# URBAN DESIGN EXPERT REPORT

## LOCKERBIE PLAN CHANGE MORRINSVILLE

Prepared by: Wayne Bredemeijer, Senior Associate, Urbanismplus Ltd  
Date: 13 July 2022

**Figure 3-1: Comparison between the original version (reviewed in late 2021) and the notified version (subject of this review) of the Development Area Plan.**

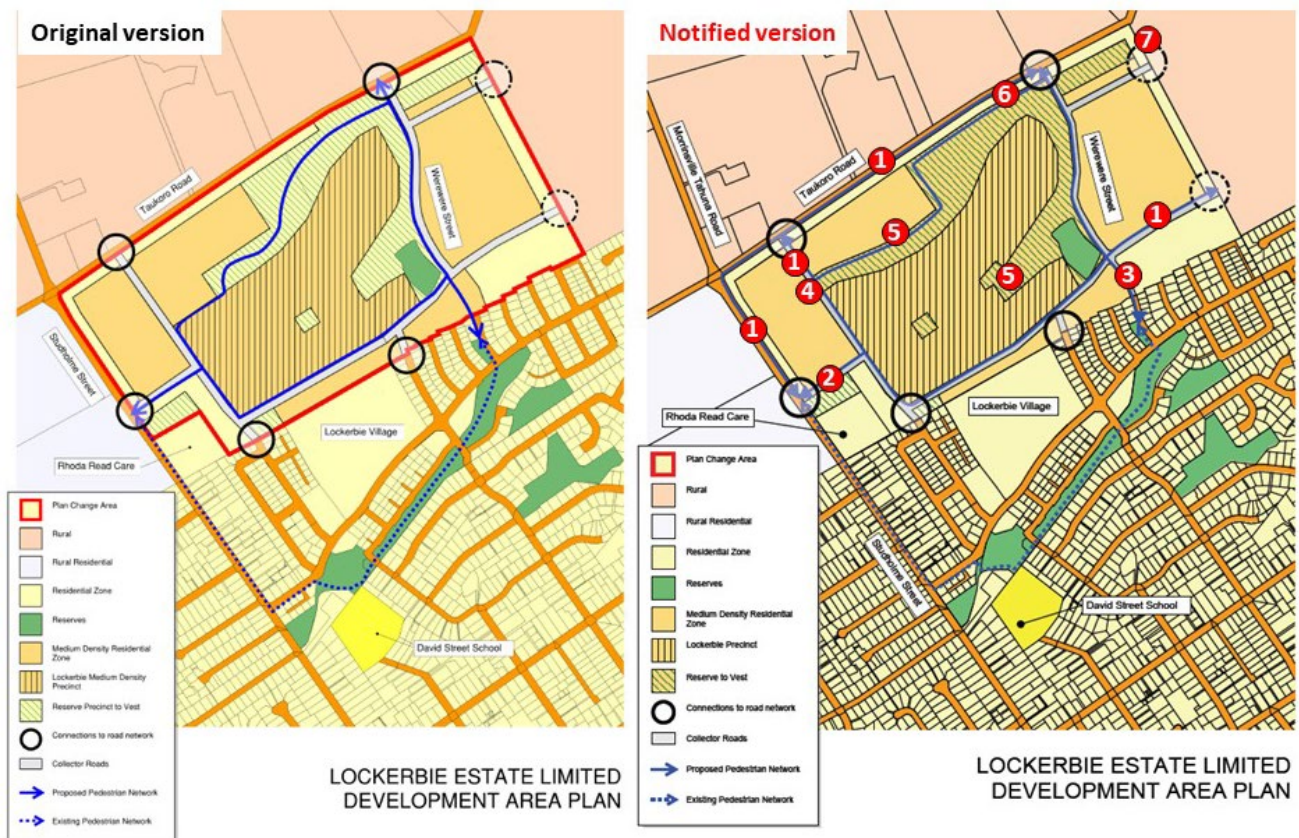
- The existing *Figure 1. Development Area Plan* has been changed as follows (refer to numbering on **Figure 3-1**):
  - 1) Several connections added to the proposed pedestrian network.
  - 2) Street interface added to south-western reserve.
  - 3) South-eastern pedestrian link now combined with street connection.
  - 4) Central reserve extended to open up to the street.

- 5) North-western MDRZ block and parts of the Lockerbie Precinct boundaries adjusted to ensure better interfaces with the reserve.
- 6) The strip of land zoned Residential Zone along the central part of Taukoro Road extended so the reserve will no longer be opened up to Taukoro Road.
- 7) The strip of land zoned Residential Zone along the northern part of the eastern site boundary extended so the entire eastern boundary will be lined with Residential Zone land instead of being interrupted with some reserve land.

The changes to the Development Area Plan are considered mostly positive and especially the following aspects are worth noting and address issues raised in the original urban design review:

- Several connections are added to the proposed pedestrian network, including along Studholme Street, along Taukoro Road, an additional connection to Taukoro Road, and a connection to the land to the northeast of the site. These connections will contribute to the urbanisation of Studholme Street and Taukoro Road and provide additional attractive options for walking and cycling.

- The stormwater reserve in the southwest of the site will now be lined with a public street (collector road) where it was formerly backed onto by lots. This will provide opportunities for passive surveillance from passing traffic and dwelling frontages, which will assist with the safety in this reserve.

- The south-eastern leg of the pedestrian network will now be combined with a street connection (collector road). This will ensure that this connection will be overlooked by passing traffic and from dwelling frontages, which will assist with the safety in this path.

- The central reserve will now open up to the street (collector road). This will provide views into this reserve from passing traffic, which will improve the safety and legibility of this area.

- The north-western MDRZ block and parts of the Lockerbie Precinct boundaries will now have better interfaces with the reserve.

The following aspects of this plan are still considered negative:

- This plan does not specify an appropriate proportion of reserve edges lined with streets (to make these perceivably public and well-overlooked areas). These streets are however specified on the PPC Area Open Space and Connectivity Concept Plan, but it is unclear what the status is of the streets shown on this plan (refer to Sections 4.2 and 4.3).

- The stormwater reserve in the northeast of the site will be hidden behind rows of lots on two long sides, giving rise to concerns about the safety of this area as it will not be overlooked by frontages and from public streets. From discussions with the applicant, it is understood that this area will not be publicly accessible. It remains however unclear how this will be enforced, what the status and ownership of this area will be, and how it will be accessed and maintained.

- The main recreational reserve will no longer be opened up to Taukoro Road as the strip of land zoned Residential Zone along the central part of Taukoro Road has been extended. This will mean that much less of the reserve will be overlooked from the north, i.e. from passing traffic along Taukoro Road.

- The narrow strip of Residential Zone lots in the very northeast of the site seems very impractical as there is no access, unless an inefficient street is constructed specifically for this narrow strip of land.

- It is unclear whether there is any flexibility in the alignment of streets and locations of zone and precinct boundaries on this plan.

**Figure 5-1: Changes to the notified version of the Development Area Plan made by the applicant in response to the initial review of the notified version and public submissions.**

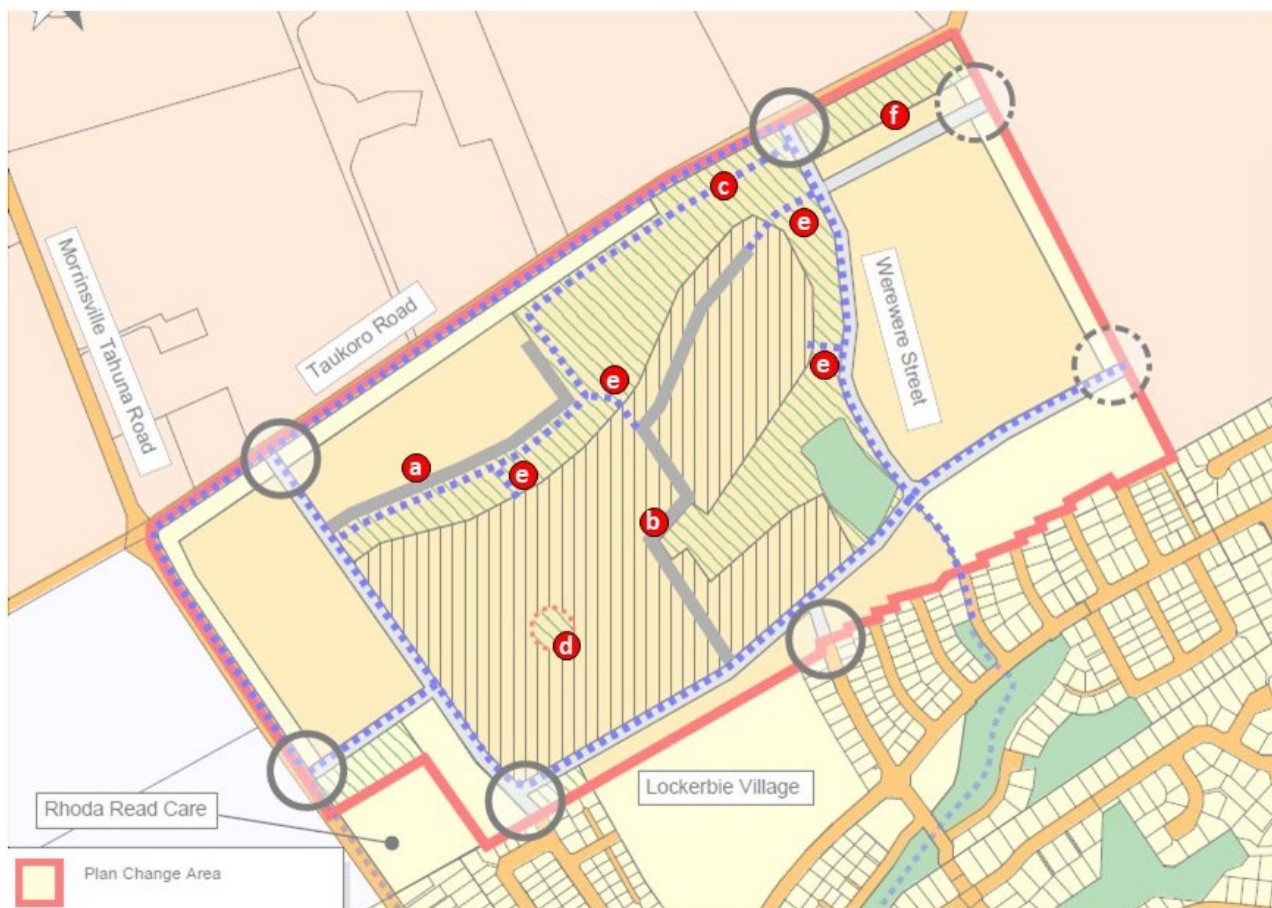
The post-notification changes to the Development Area Plan are listed below and indicated on **Figure 5-1** (refer to the numbering on this figure).

- a) A local street along the reserve edge in the northwest of the site has been added, as indicated. This will provide legibility, a perceivable public character, and passive surveillance from the street and properties fronting this street over this part of the reserve.
- b) A local street along the reserve edge in the centre of the site has been added, as indicated. This will provide legibility, a perceivable public character, and passive surveillance from the street and properties

fronting this street over this part of the reserve, which will otherwise be relatively hidden behind backs of lots.

- c) The strip of Residential Zone located along Taukoro Road has been shortened and partly changed to Reserve, as indicated. This will increase the interface of the reserve with Taukoro Road, which is crucial for the amenity, safety and character of this area and which will also help the development to better integrate into the context of the site's location at the interface with the surrounding rural area.

- d) The location and shape of the proposed Neighbourhood Park Streets has been changed to indicative so it will be able to be integrated with the finer-grain street network as and when designed. Additionally, a rule has been added requiring that subdivision and development within the Lockerbie Development Area Plan should be considered against the principle, among others, that streets should be provided on at least two sides of the neighbourhood park. This is crucial for the legibility and a perceivable public character of this park, as well as to enable passive surveillance from the street and properties fronting this street over this neighbourhood park.

- e) Pedestrian connections integrated with the wider street network will link across the stream in at least the four locations indicated.
- f) The stormwater reserve in the northeast of the site will now be located along, and be overlooked from, Taukoro Road, as indicated. This reserve, as opposed to a strip of Residential Zone lots, will also form a suitable transition between rural and urban, and present this stormwater reserve to those approaching Morrinsville from the north. This will help the development to better integrate into the context of the site's location at the edge of Morrinsville and interfacing with the surrounding rural area. Medium Density Residential Zone land in this area has also been extended to the north and the east-west collector road shifted accordingly.

### **Section 5.3. Review of the post-notification changes**

The post-notification changes to the Development Area Plan have alleviated all concerns indicated in the earlier review. The changes will contribute to appropriate urban design outcomes, balanced with commercial reality. The following high-level outcomes of the post-notification process should be noted:

- Increased legibility, public character, and passive surveillance from roads, streets and properties over open spaces.
- Greater connectivity for active modes.
- Better integration of the proposed development into the context of the site's location at the edge of Morrinsville and interfacing with the surrounding rural area.
